File: swarmIR.sch		
Sheet: /		
Title:		
Size: A4	Date: 26 oct 2012	Rev:
KiCad E.D.A.		Id: 1/1

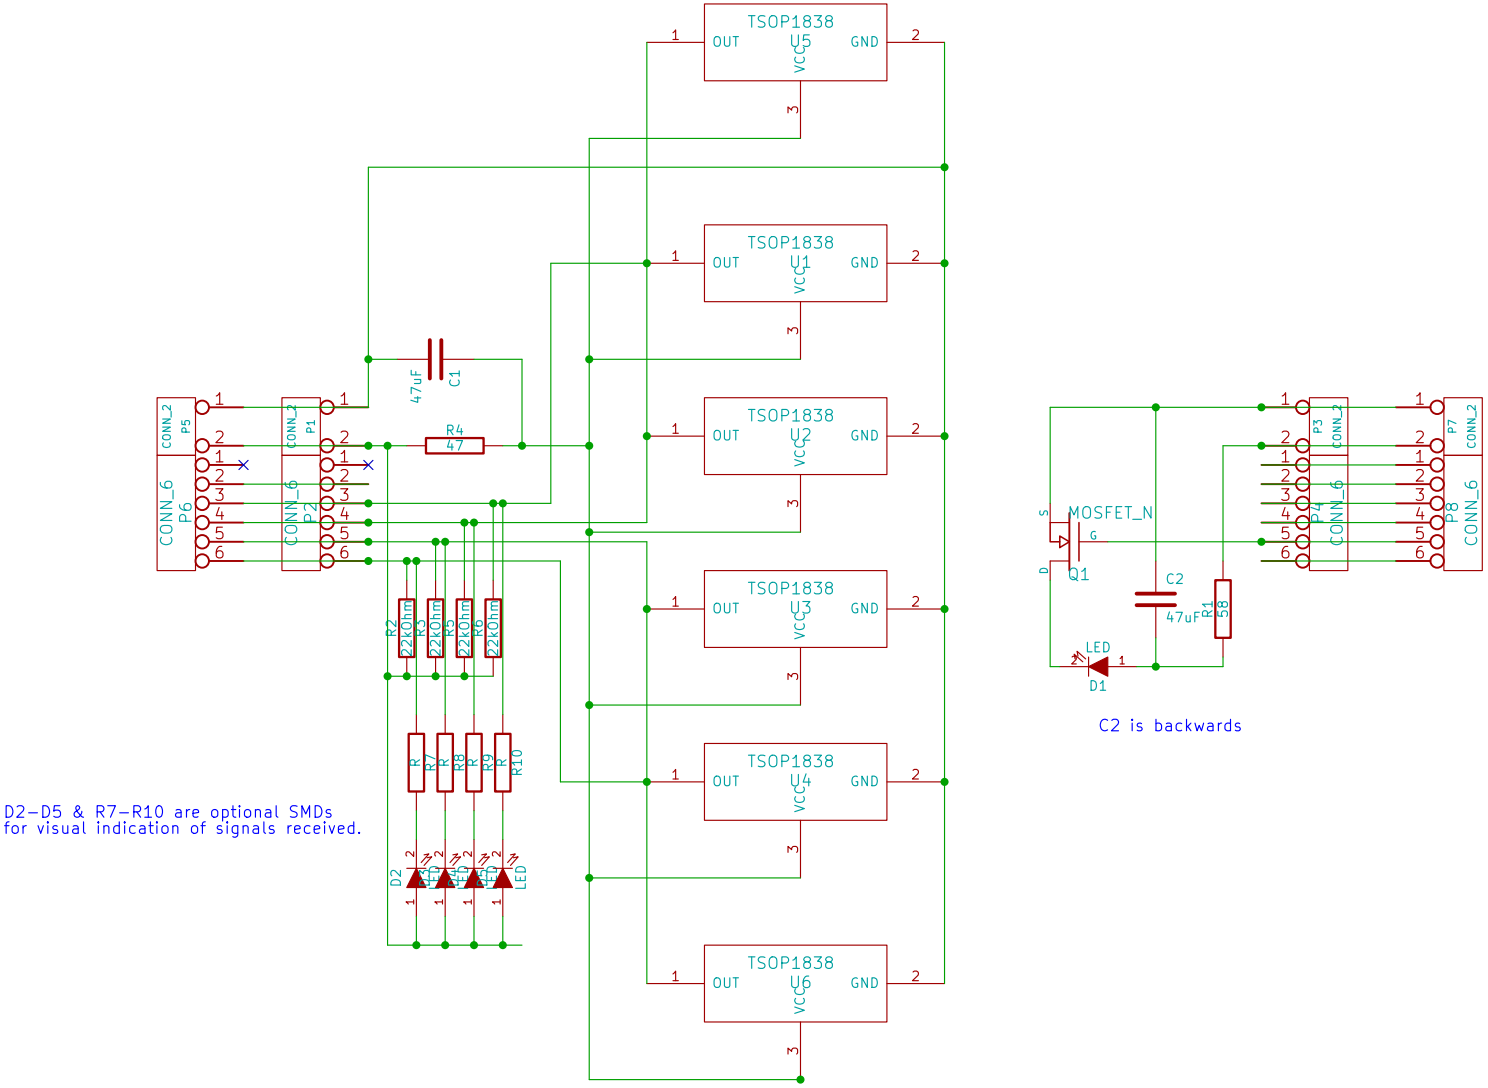
C2 is backwards

** NOTE: Extra IR receiver LEDs are on the board so they can be tested in different positions!
The outputs of U4 & 6 are connected together. Same with U2 & U5.

So only use ONE of each pair! They will not work with both LEDs in one pair connected!
